XPS-APF Replaced by XPS-AR

Differentiation

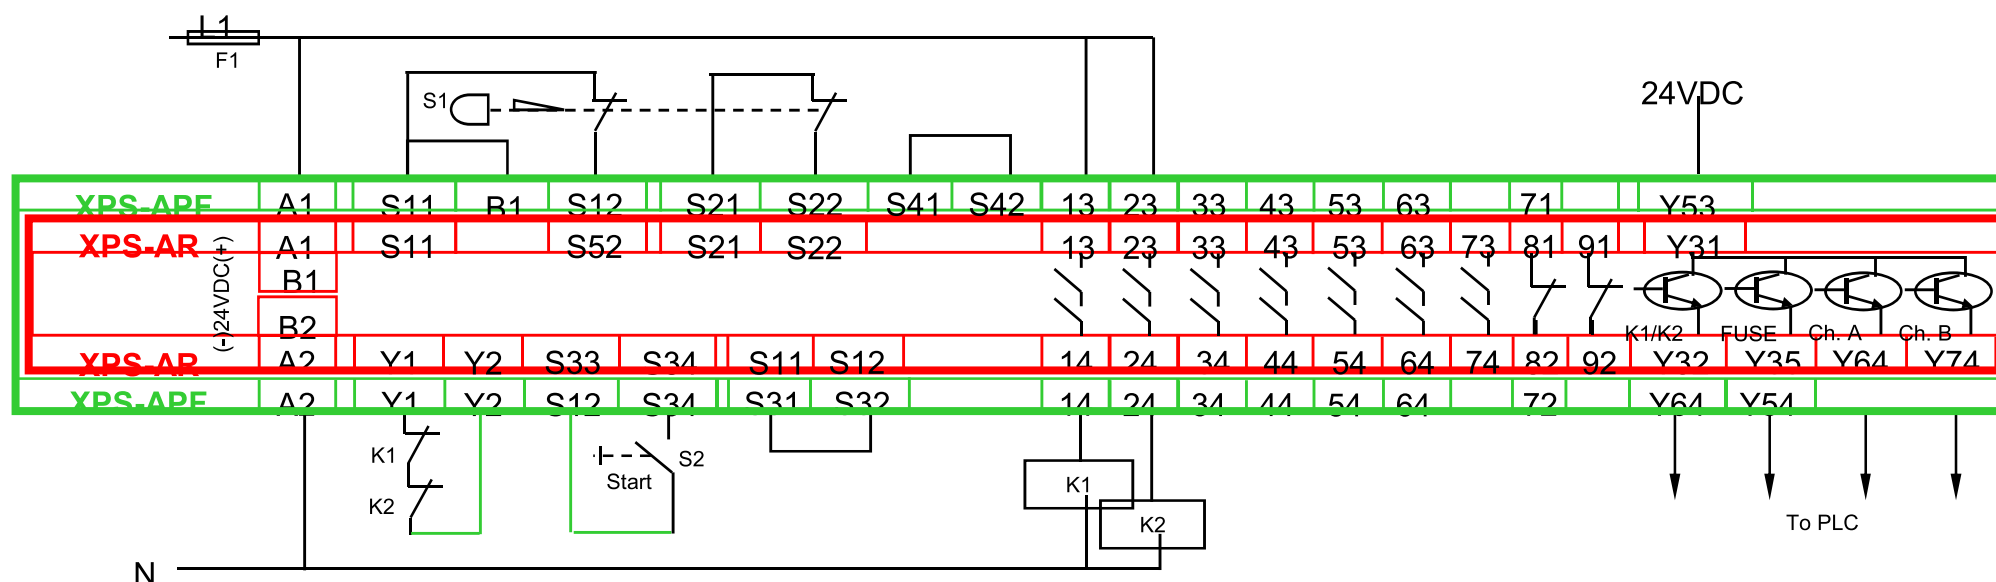
- XPS-AR has 2 extra solid state outputs for PLC signalling
- XPS-AR has choice of removable plug terminals
- XPS-AR has 1 extra N/O safety outputs
- XPS-AR cannot monitor safety mats or edges
- XPS-APF can be used for Type III A two-hand control monitoring
